WLTP UNR Development (based on WLTP-28-09e)

Agreed proposals within WLTP Sub Group EV

Figure A8/2

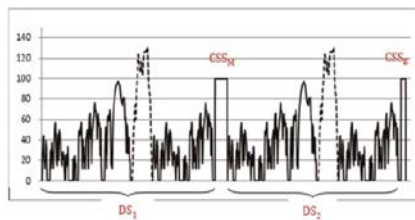
- In the referred paragraph, it is only described how to accelerate to reach the speed in the constant speed segment but it is not described how to decelerate
- Proposal adds a sentence which also describes how to decelerate from constant speed to stand still

The deceleration from the constant speed level shall be smooth and accomplished within 1 minute after completion of the constant speed segments.
